San Diego, USA, Feb 29- Mar 3, 2000

Source: Philips
Title: Clarification of DCH initialisation
Document for: Decision

25.211 CR 041

Clarification of DCH initialisation

Figure 27: Timing for initialisation of DCH.

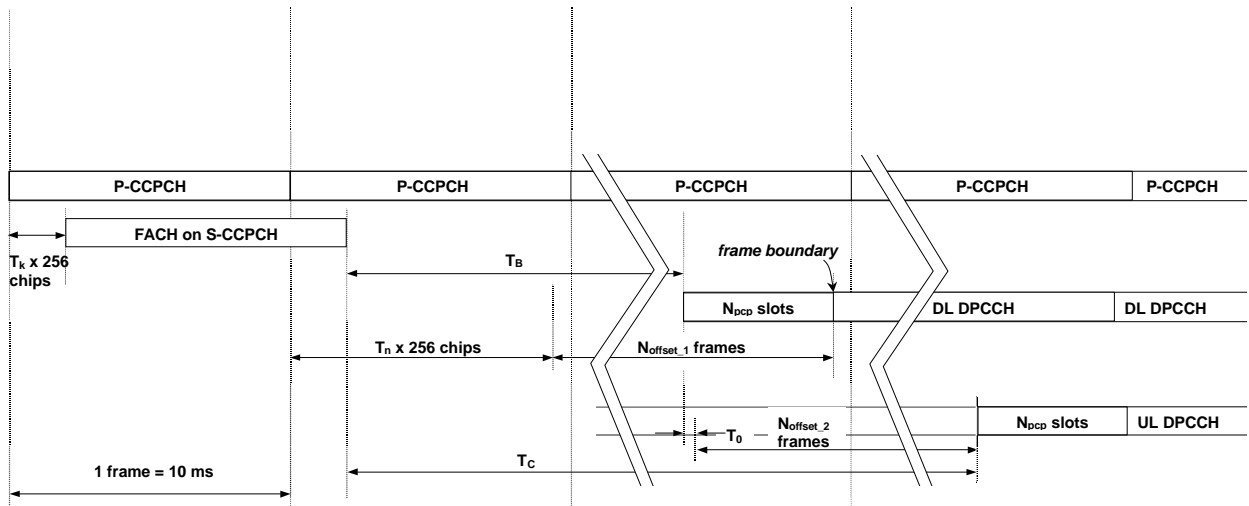
Figure 27 shows the timing relationships between the physical channels involved in the initialisation of a DCH.

$T_C = T_B + T_0 + N_{offset_2} \times 38400$ chips, where T_0 is as in section 7.6.3. If an activation time for the uplink DPCCH is specified, then N_{offset_2} shall be set to zero. Otherwise the starting time of the uplink DPCCH shall be determined by higher layers according to the procedure in TS 25.214 sub clause 4.3.2, subject to the constraint that ~~and~~ N_{offset_2} is a UE-specific higher layer parameter which shall be an integer number of frames greater than or equal to zero.
